# Technical Service Bulletin

<b>Subject:</b>  VIBRATION WHEN DRIVING AT 1500-1650 RPM	<b>Bulletin No.:</b> 01-001/25
	<b>Last Issued :</b> 02/06/2025

This bulletin supersedes the previously issued bulletin(s) listed below. The changes are noted in Red text.

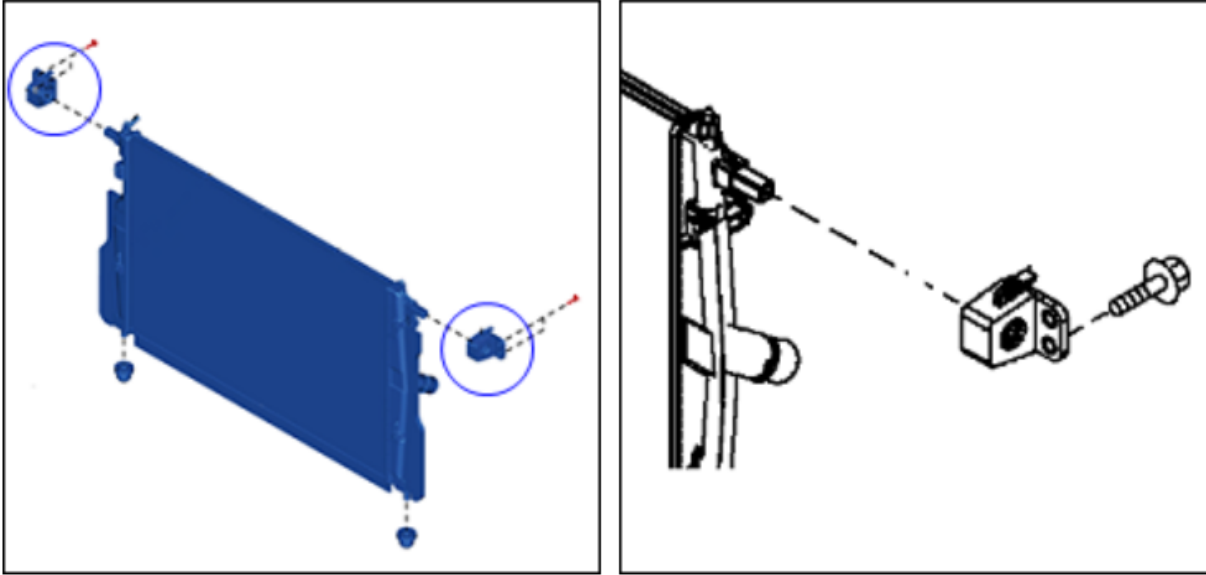
Some customers may complain about a very low frequency noise and/or vibration felt at the steering wheel, the floor and/or the seats when driving at 1500-1650 rpm in any gear position. This may be caused by normal vehicle behavior while the cylinder deactivation is active (two cylinders drive). The state of the cylinder deactivation can be monitored in the center display to help verify if this is the issue.

To correct this concern, the radiator mount brackets and the control software of the PCM have been modified to reduce the resonance of the radiator.

1. Verify customer concern. The state of the cylinder deactivation can be monitored in the center display to help verify if this is the issue.

2. Replace the radiator mount brackets with modified ones.

**Bolt tightening torque: 71-88 in-lb (82-101 kgf-cm, 8-10 Nm)**
